Re: Subdivision Review Application for Final United Village Development Plat by
Snelling-Midway Redevelopment

LOUCKS COMMENTS TO THE PRELIMINARY PLAT CONDITIONS TO BE INCORPORATED INTO THE FINAL PLAT (Red Text)

Approving the Preliminary Plat for United Village Development.

COMMENT #3

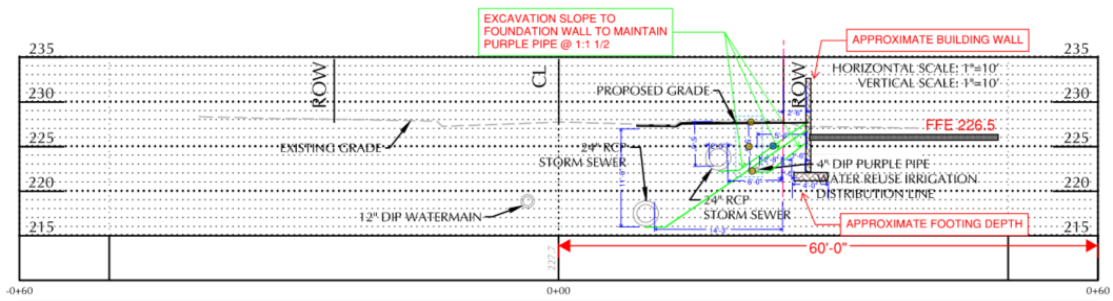
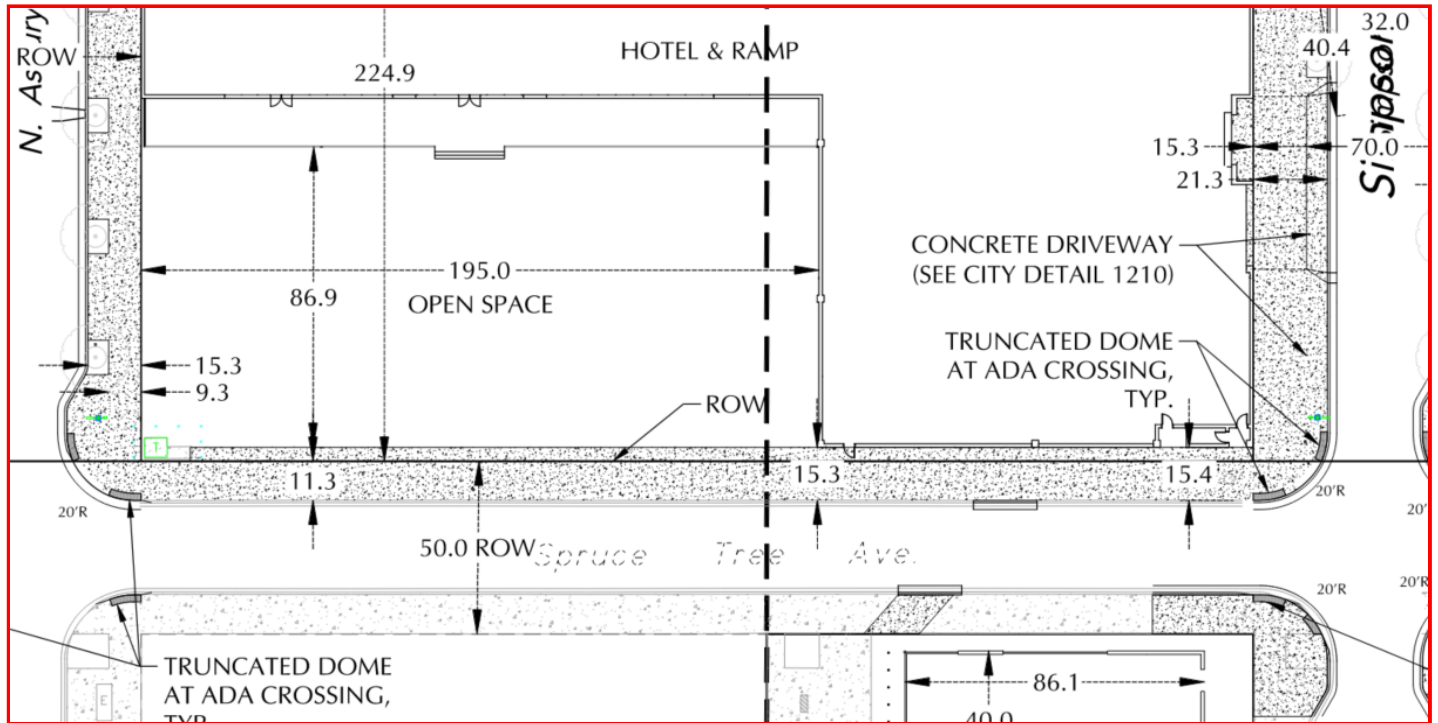
The developer must incorporate the results and recommendations of the recommendations of the Snelling-Midway Superblock Sanitary Sewer Analysis study, a sanitary sewer capacity analysis being completed for the City by consultant SEH, into the currently proposed development phase as well as all future phases and future private developments to be built on the site. **This was included in Loucks 60% Construction Plan Submittal. See Attached.**

Midway Superblock Sanitary Sewer Calcs
